# FINAL ENVIRONMENTAL IMPACT STATEMENT

U.S. DEPARTMENT OF THE NAVY  
NAVY AIRCRAFT DESIGN  
AND DEVELOPMENT  
ACTIVITY  
PACIFIC AIR FORCE  
HAWAII

## Appendix I Comments and Responses

Figure 3.3-11  
Installation Restoration Program Sites Near  
Proposed Construction Sites - MCAS Cherry Point

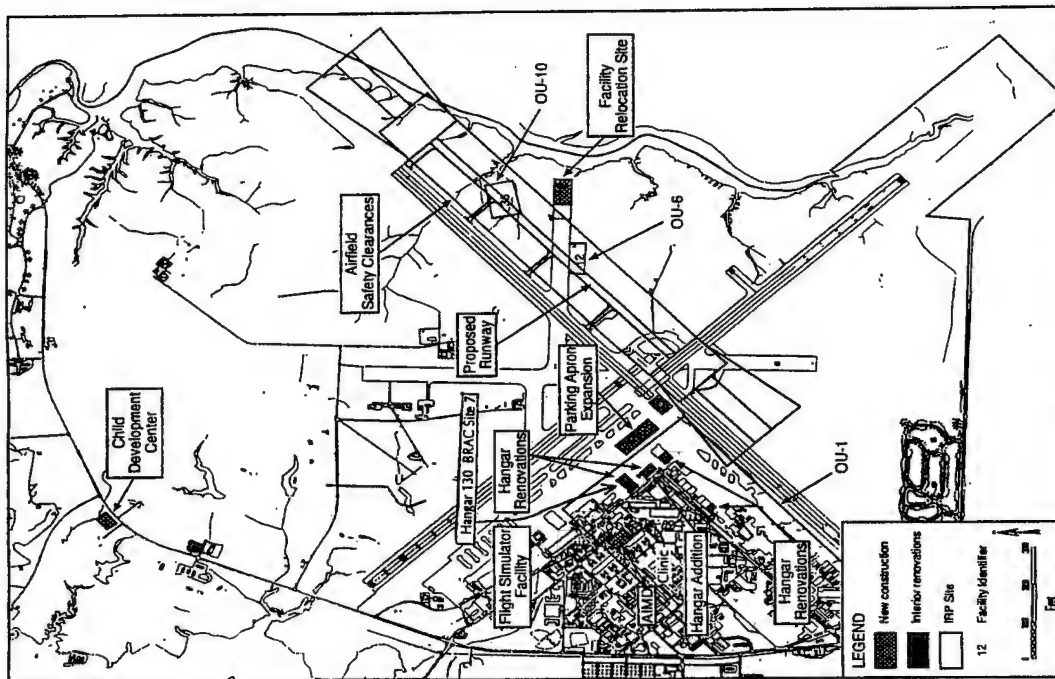
The plans and specifications for any projects located near OU-1, Site 35, OU-6, and Site 12 would have to incorporate procedures for handling potentially contaminated soils and/or groundwater. In addition, properly trained personnel would be required to oversee testing of any potentially contaminated soils or groundwater. The Navy would also ensure that construction would not interfere with any remediation activities. As recommended, the child care facility would require a survey to determine if hazardous substances are present.
